Sheet_1

Company: Your Company

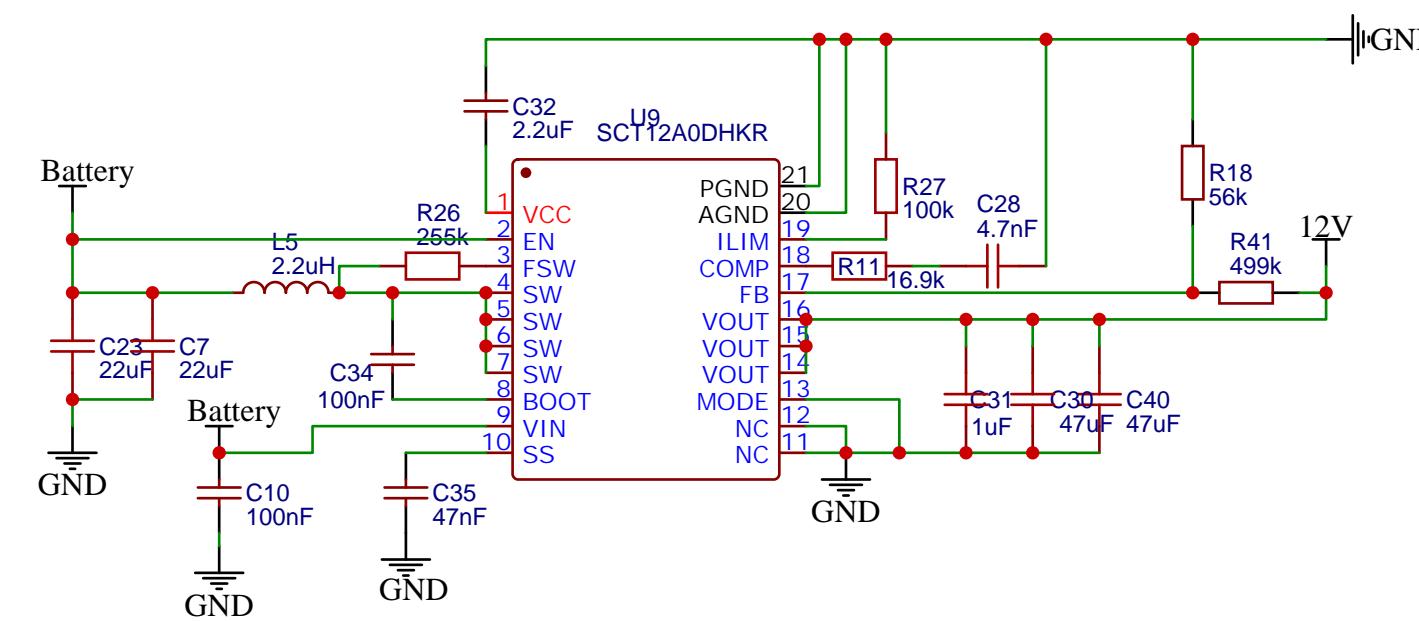
Make the 12V trace between the Boost and the ESC thick (at least 1.5mm to 2.0mm wide) to minimize inductance over that 3cm distance.
